BELLEFONTE COMBINED LICENSE APPLICATION – RESPONSE TO REQUEST FOR  
ADDITIONAL INFORMATION – EVACUATION TIME ESTIMATE

Responses to NRC Request for Additional Information letter No. 069 dated July 11, 2008  
(18 pages, including this list)

**NRC RAI NUMBER: 13.03-08**

**Figure 3-6. Employee Population by Sector**

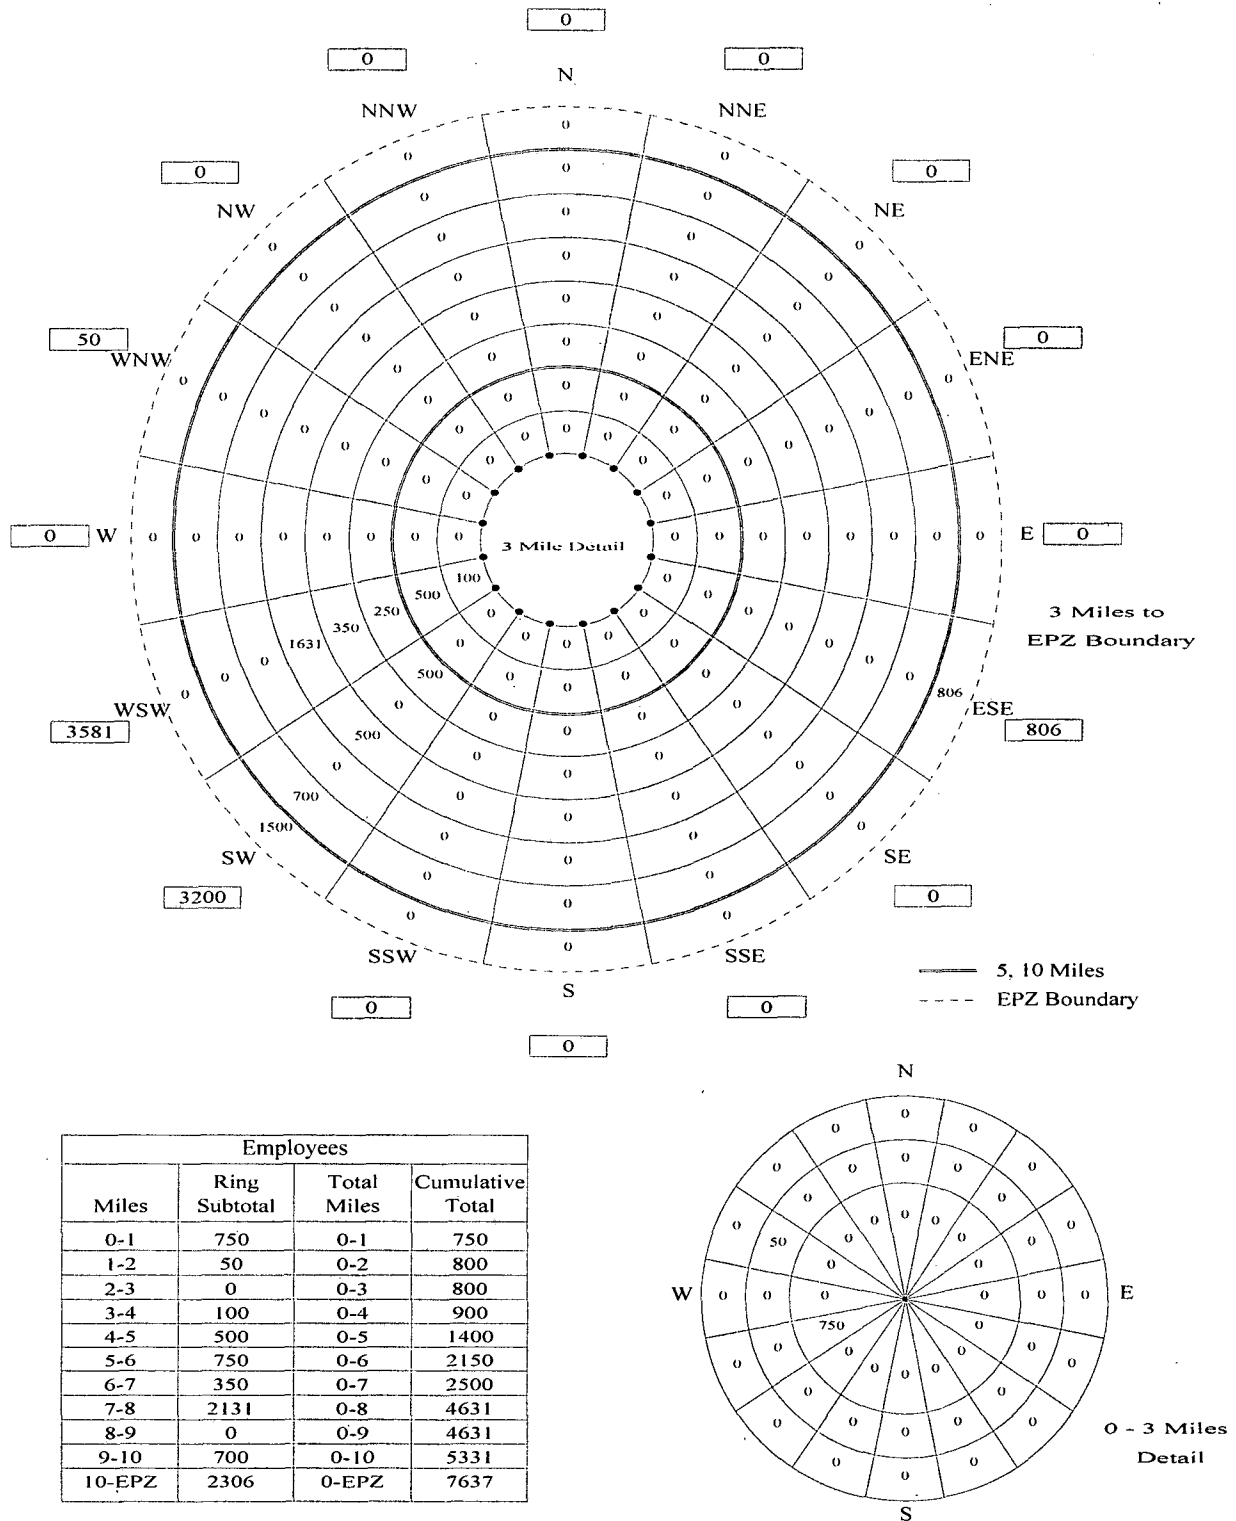
- Corrected by moving the figure "806" for the ESE, 9-10 mile cell to the ESE, 10-EPZ boundary cell. Corrected the table summarizing employees in the lower left corner of the Figure accordingly. See corrected figure provided in this Errata Sheet.

**Figure 3-7. Employee Vehicles by Sector**

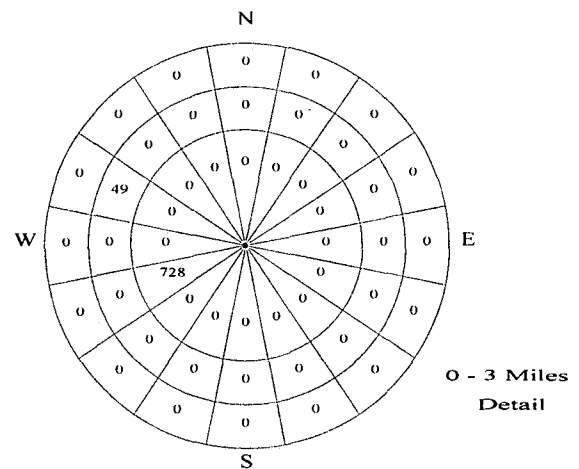
- Corrected by moving the figure "783" for the ESE, 9-10 mile cell to the ESE, 10-EPZ boundary cell. Corrected the table summarizing employee vehicles in the lower left corner of the Figure accordingly. See corrected figure provided in this Errata Sheet.

Figure 5-1. Events and Activities Preceding the Evacuation Trip

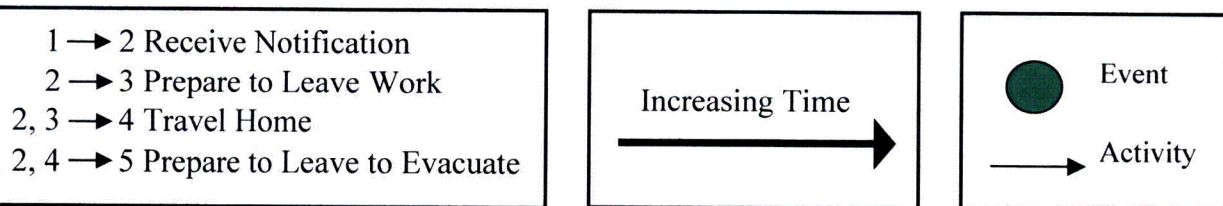
(a) The unnumbered table with column headings "Event Number" and "Event Description" on page 5-4 of the BLN ETE differs from the legend in Figure 5-1, "Events and Activities Preceding the Evacuation Trip." The legend in Figure 5-1 appears to agree with the text that follows. Event numbers (page 5-4) evidently lead to Event Sequences in Table 5-1, "Event Sequence for Evacuation Activities," associated with Activities, each of which is associated with a numbered time distribution. The numbers 1-5 in the legend of Figure 5-1 do not correspond to the numbers 1-5 in the unnumbered table on page 5-4, but rather to the activities in Table 5-1, even though there are only 4 activities in that table and there are 5 numbers in Figure 5-1. In the four headings beginning "Time Distribution...", Activities seem to be associated with a numerical sequence such as 1 & 2, whereas in Table 5-1 activities are associated with distribution numbers and event sequences, neither of which match the numerical sequences in the "Time Distribution..." headers. Some items associated with numbers are events, others are either mislabeled or are intervals between events (sometimes called "evacuation activities" or "activities" in the BLN ETE). The word "activity" has a different meaning in the legend of Figure 5-1 than it has in the caption of Figure 5-1. Explain why the methodology as presented leads to valid evacuation time estimates, or clarify and eliminate ambiguities in the text, tables, and figures of Section 5, "Estimation of Trip Generation Time."

- Corrected Figure 5-1 to agree with the text on Page 5-5. See corrected figure provided in this Errata Sheet.

Figure 1-2

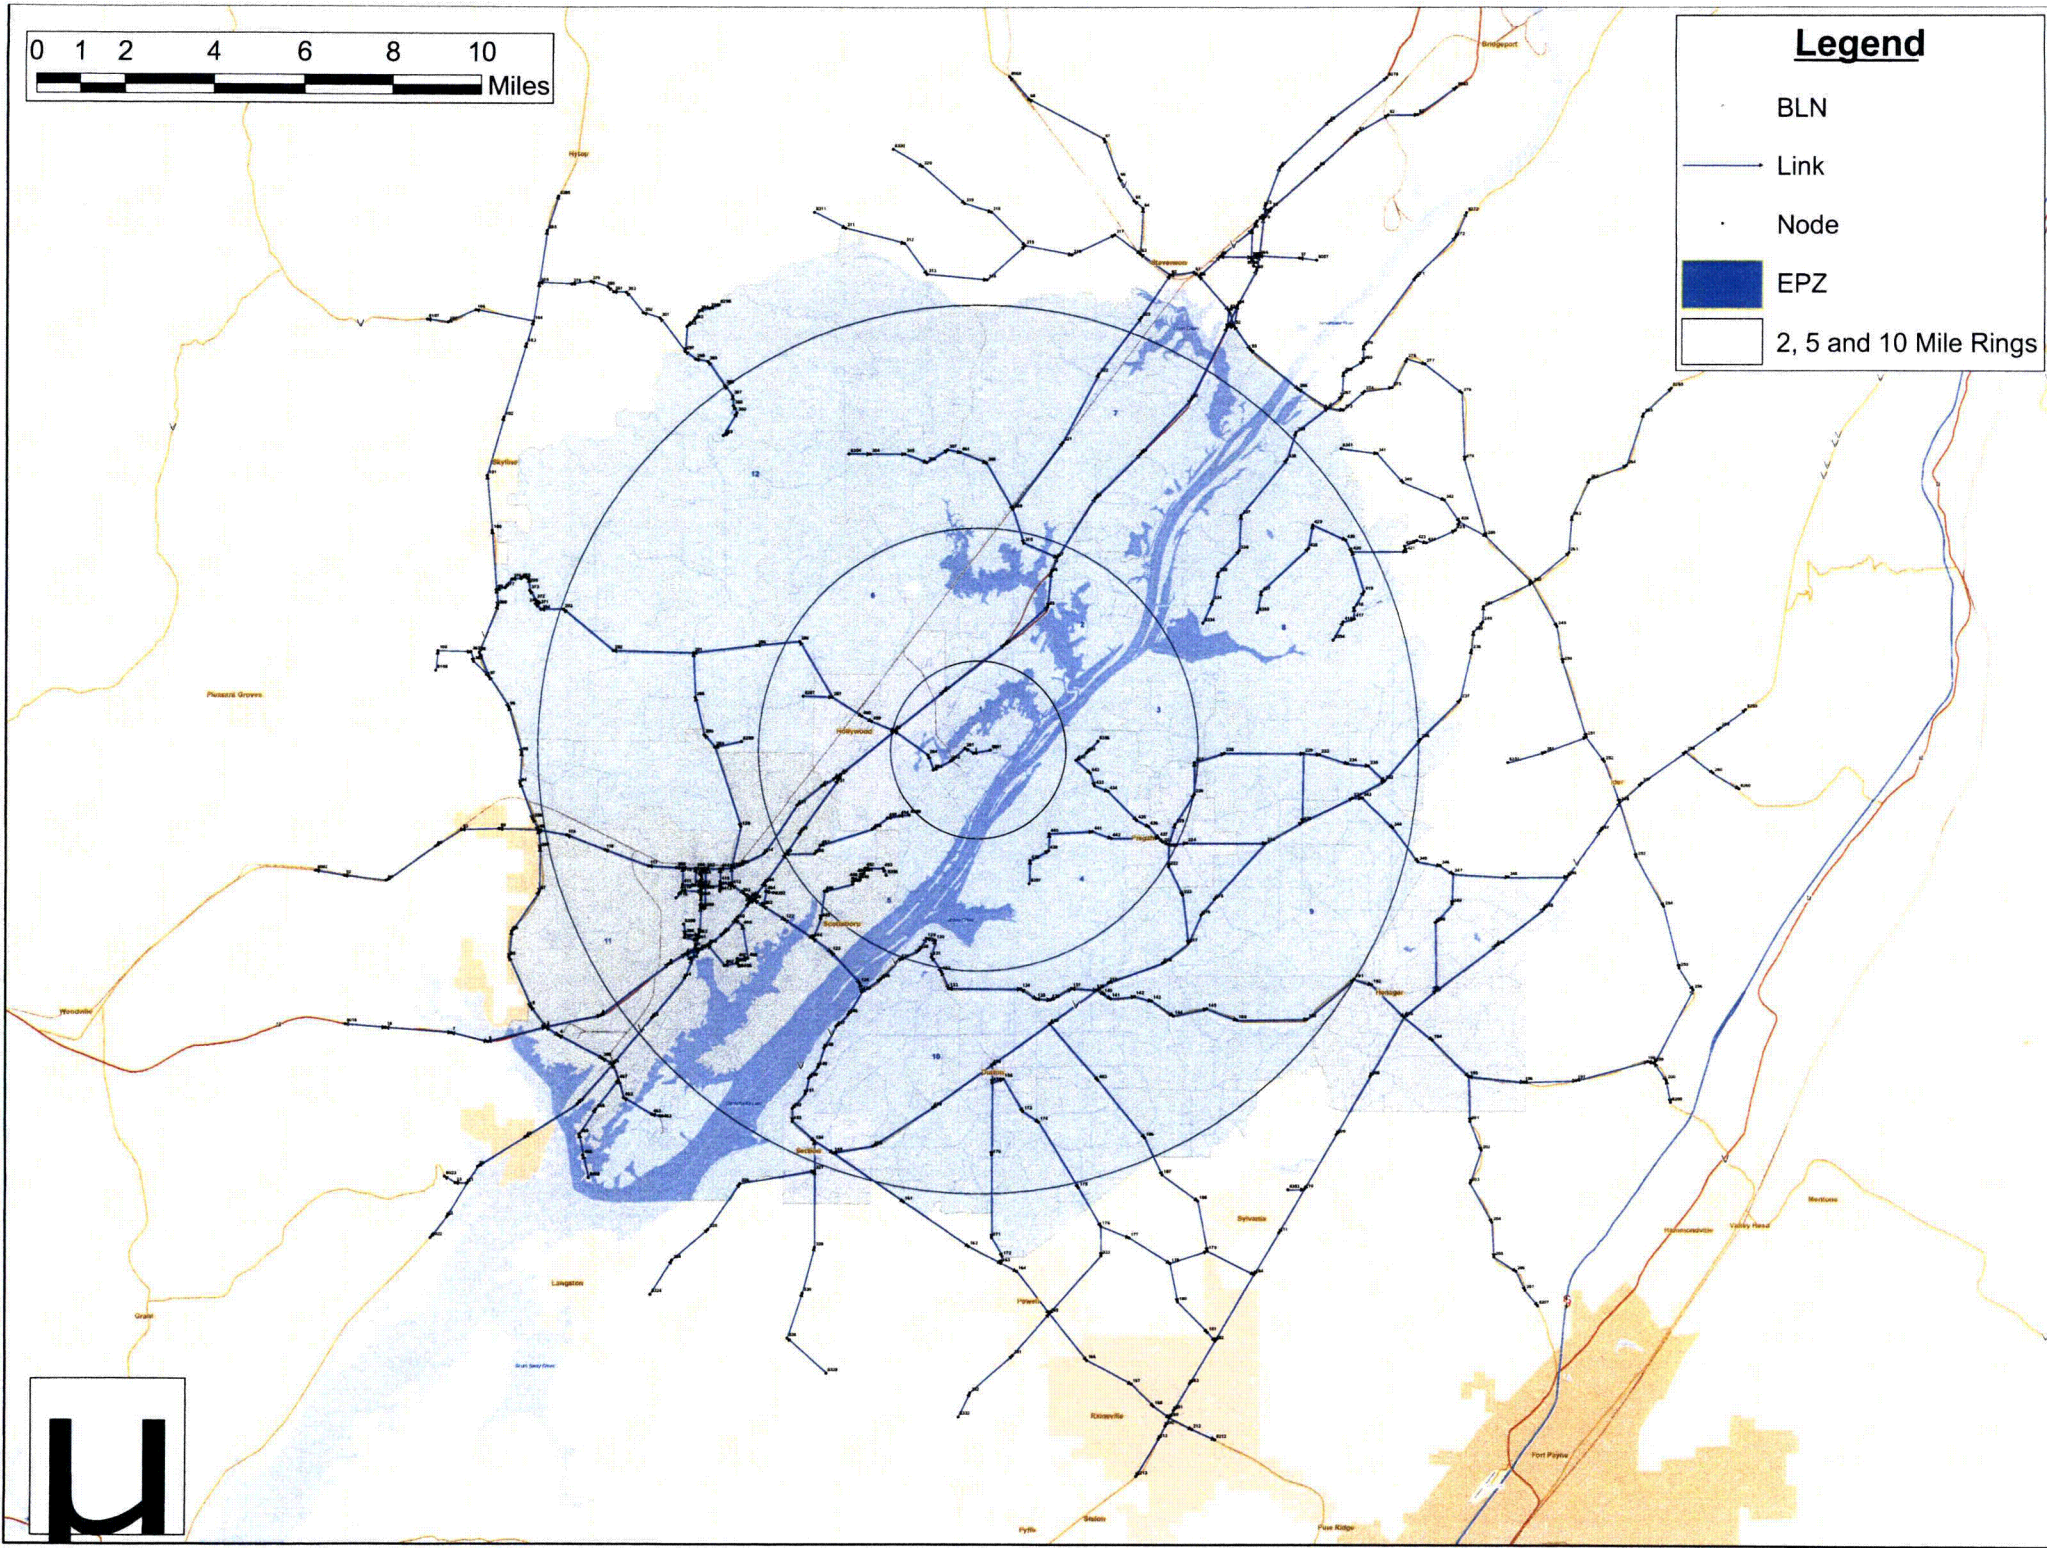
(a) Provide a map or maps that include the nodes and numbering identified in Appendix K, "Evacuation Roadway Network Characteristics." The ERPA boundaries should also be indicated on the map(s). The existing node network on Figure 1.2, "Bellefonte Link-node Analysis Network," appears to have considerably fewer segments and nodes in the north and northwest region as compared to the rest of the EPZ. The populations in this area are comparable to those in the south and southeast regions. Discuss how the number of nodes in the north and northwest region adequately represent the roadway network.

(a) Given the number of nodes, a 48 inch by 36 inch PDF file of Figure 1-2, exported at a resolution of 400 dpi from the original GIS file, has been provided with Supplement 1, to the Bellefonte ETE Report. The node numbers (from Appendix K) are labeled in the map. The link-node analysis network is developed by modeling all major evacuation routes within the EPZ and Shadow Region. Figure 3-1 shows that there are several major evacuation routes in the south and southeast sectors – State Highway 35, State Highway 71 and State Highway 40. There is, however, only one major evacuation route servicing the north and northwest sectors – US Highway 72. Also, Figure 3-6 indicates that the population in the south and southeast regions is more than 3 times that of the population in the north and northwest sectors.

COLA Part 5, EP, ETE will be updated to reflect a change to Figure 1-2. The change was previously provided (Reference 2) and is also provided in the enclosed Supplement 1, Revision 1 to the Bellefonte ETE Report which is included as Attachment 13.03-01A, revised.
